Access Compliance Report

Public Rights-of-Way

(Curb Ramps)

Intersection ID: 8588	Main Street: HYDE_DR	Cross Street: W_CRAIGHEAD_RD	Location: NW
ADA ID: 0574F6CDC177	Ramp Type: Combination2	Initial Pass/Fail: Fail	Overall Compliance: No
		Severity Score: 10

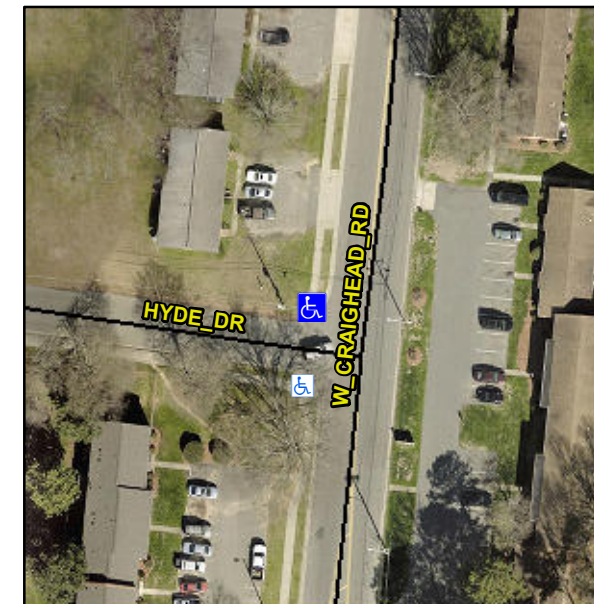
LT RP < 5%

Not Found, R304.5.1, R304.5.3

Remove & Replace Entire Ramp.
